SERVICE BULLETIN NO. 159
"FAA (DER) APPROVED"

DATE: FEBRUARY 25, 1977

SUBJECT: CARBURETOR HEAT VALVE INSPECTION/REPLACEMENT

SERIALS AFFECTED: AA5-0641 thru AA5-0834
AA5A-0001 thru AA5A-0321

FIGURE 1

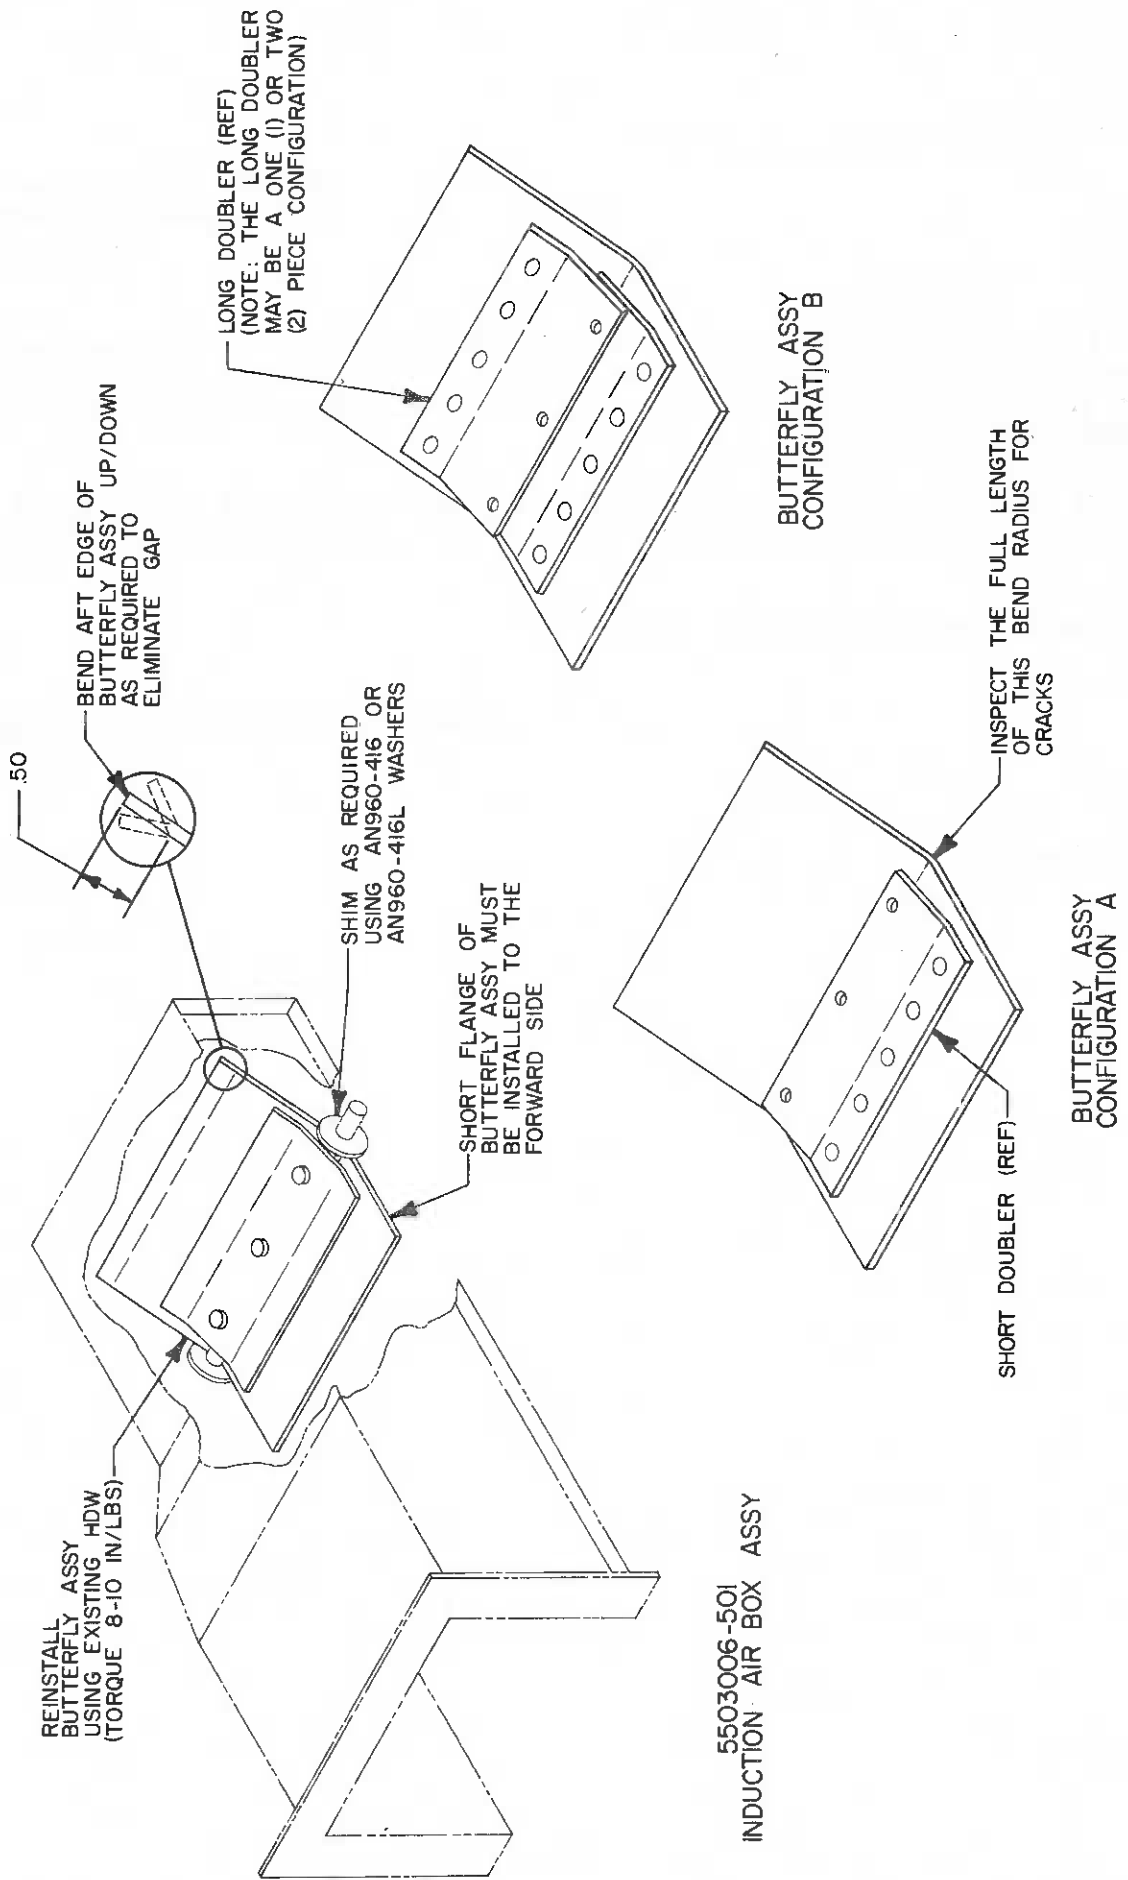
Field reports indicate that the carburetor heat valve may be subject to failure with possible interruption of the airflow to the carburetor. A new butterfly valve assembly, Part No. 5503006-505 has been designed with increased strength to reduce the possibility of failure in this area.

- I. Initial Inspection-before further flight, remove the lower cowl and inspect the carburetor heat valve assembly for configuration as shown in FIGURE 1. If configuration "A" exists, remove the valve assembly and inspect for cracks in the bend radius. If cracks are found, remove valve assembly from service and replace with a new valve assembly Part No. 5503006-505. Destroy removed valve assembly. Do not reuse.

1. After valve assembly is installed into air box assembly, temporarily install air box assembly onto lower cowl. Remove air filter and check the forward and aft gap between the valve assembly and carburetor heat box/lower cowl contact points. Maximum gap is .120 inches at both ends of valve with carburetor heat in the on and off position. If excessive gap exists, remove air box assembly and crimp edge of valve assembly up or down as required to arrive at the minimum gap (SEE FIGURE 1).

1. Visual inspection before further flight. If carburetor heat valve of configuration "A" indicates cracks along bend radius, replace with new valve of configuration "B" and check carburetor heat control rigging.
2. If initial inspection indicates no cracks along bend radius of valve and carburetor heat control rigging is in accordance with Service Manual, aircraft may be flown an additional 25 hours.
3. After 25 hours, reinspect valve and cable rigging. If no discrepancies are noted, the aircraft may be flown an additional 25 hours. The configuration "A" valve must be replaced with the new configuration "B" valve at the end of this period.

UNDER NO CIRCUMSTANCES SHOULD THE CONFIGURATION "A" VALVE BE FLOWN IN EXCESS OF 50 HOURS.

- II. Subsequent Inspection-if no cracks are found in configuration "A" valve assembly, valve assembly may be reinstalled and temporarily returned to service for twenty-five (25) hours of operation. At the end of this time period the valve assembly must undergo the initial inspection procedure as described in Part I of instructions. If no cracks are evident at the second inspection of configuration "A" valve assembly, the valve assembly may be reinstalled and returned to service for a final twenty-five (25) hour operational period. Under no circumstances shall a configuration "A" valve assembly remain in service beyond fifty (50) hours of operation.

2. Following cowl installation, perform engine run up to check carburetor heat drop (50 RPM drop minimum). If drop does not meet minimum requirements, rework valve per paragraph No. 1 above.
